APPLICATION NO.	FILING DATE	FIRST NAMED INVENTOR	ATTORNEY DOCKET NO.	CONFIRMATION NO.
10/594,904	04/25/2007	Kazuto Sakemura	46969-5456	8306
	7590 05/20/200 DDLE & REATH (DC)	EXAMINER		
1500 K STREE SUITE 1100		BOWMAN, MARY ELLEN		
	N, DC 20005-1209		ART UNIT	PAPER NUMBER
			2879	
			MAIL DATE	DELIVERY MODE
			05/20/2009	PAPER

Application No.	Applicant(s)				
Office Action Occurrence	10/594,904	SAKEMURA ET AL.				
Office Action Summary	Examiner	Art Unit				
	MARY ELLEN BOWMAN	2879				
The MAILING DATE of this communication app Period for Reply	ears on the cover sheet with the c	orrespondence ad	dress			
A SHORTENED STATUTORY PERIOD FOR REPLY WHICHEVER IS LONGER, FROM THE MAILING DA - Extensions of time may be available under the provisions of 37 CFR 1.13 after SIX (6) MONTHS from the mailing date of this communication. - If NO period for reply is specified above, the maximum statutory period w - Failure to reply within the set or extended period for reply will, by statute, Any reply received by the Office later than three months after the mailing earned patent term adjustment. See 37 CFR 1.704(b).	ATE OF THIS COMMUNICATION 36(a). In no event, however, may a reply be time will apply

Fig. 2

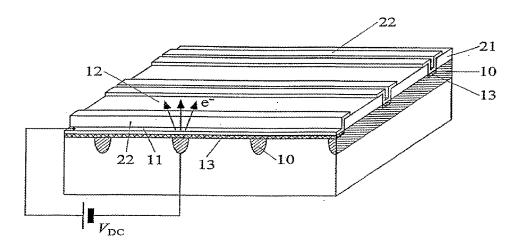
Applicant's arguments filed February 10, 2009 have been fully considered but they are not persuasive. Applicant's first argument that Brune fails to teach a bridging portion provided with a through hole or notched portion is not persuasive. Electrode 22 has a notched portion as shown in Figure 2 of the Office Action. The "notched portion" as considered by Examiner, is the portion that extends between the electron emitting elements. It is "notched" because it falls below the level of the rest of the electrode and falls down into the gap between the electron emitting elements.

elements and the space by a bridging portion of the upper electrode (e.g., Figure 2 below; upper electrode 11 extends across the space between the electron emitting elements 12), and wherein the bridge portion is provided with at least one through hole or notched portion (e.g., Figure 2 below, upper electrode 11 is provided with a notched portion corresponding to the bridge portion of the electrode that extends over electron emitting elements 12).

Regarding claim 3, Brune teaches the invention as explained above regarding claim 1 and further teaches the through hole or notched portion is circular-shaped, rectangular-shaped, diamond-shaped, barrel-shaped, star-shaped, shoulder drum shaped, or a shape formed of part of these shapes (e.g., Figure 2 above, the notched portion of upper electrode 11 is rectangular shaped).

(e.g., Figure 2 above, the bridge portion of the upper electrode 11 which extends over electron emitting elements 12 is approximately parallel to the substrate).

Regarding claim 5, Brune teaches the invention as explained above regarding claim 1 and further teaches both the lower electrode, and the upper electrode connected at the bridging portions or strip shaped electrodes arranged in positions that are mutually orthogonal (e.g., Figure 2 above, stripe shaped lower electrode 10 and stripe shaped upper electrode 11 intersect at the bridge portions and are mutually orthogonal).

Fig. 2

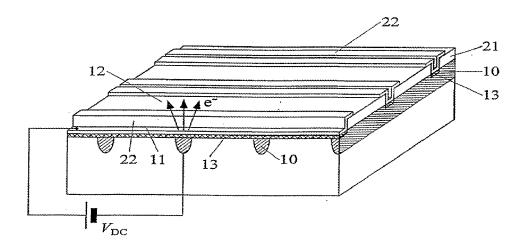
Regarding claim 10, Brune teaches the invention as explained above regarding claim 1 and further teaches at least one electron emitting section formed from an island area in which the film thickness of the insulator layer and the upper electrode gradually decreases towards the electron supply layer (e.g., Figure 2 below, the thickness of the insulator layer 21

and upper electrode layer 11 steps down, or gradually decreases, to form island areas over each electron emitting element).

Regarding claim 11, Brune teaches the invention as explained above regarding claim 10 and further teaches in the island areas the upper electrode terminates on the insulator layer (e.g., Figure 2 above, upper electrode 11 terminates as metal layer 22 on insulator layer 21).

Regarding claim 12, Brune teaches the inventions as explained above regarding claim 10 or 11 and further teaches in the island areas the insulator layer terminates on the electron supply layer (e.g., Figure 2 above, insulator layer 21 terminates on electron supply layer 13 at the island areas).

Regarding claim 13, Brune teaches the invention as explained above regarding claim 10 and further teaches the island areas are depressions in the flat surface of the upper electrode (e.g., Figure 2 above, island areas are depressions in the flat surface of upper electrode 11).

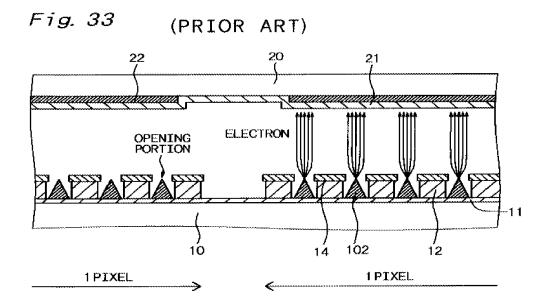
photoelectric conversion film] formed between the anode electrode layer 21 and the transparent substrate 20"; see Figure 33 below).

Regarding claim 25, Kikuchi teaches the invention as explained above regarding claim 25 and further teaches a mesh electrode arranged within the vacuum so as to not contact the electron emitting device of the photoelectric conversion film (e.g., Figure 33 above, gate electrode 14 is a mesh electrode within the vacuum that does not contact the electron emitting element 12).

Regarding claim 26, Kikuchi teaches a display device comprising: the invention as explained above regarding claim 1; and an optically transparent front substrate in opposition to the upper electrode (e.g., Figure 33 above, transparent substrate 20) and enclosing a vacuum space, with a fluorescent layer arranged on the surface on the side of the vacuum space (e.g., Figure 33 above, fluorescent layer 22), and a collector electrode formed on the fluorescent

layer and in opposition to the upper electrode (e.g., Figure 33 above, collector electrode 21 is formed on fluorescent layer 22 and opposite upper electrode 14).
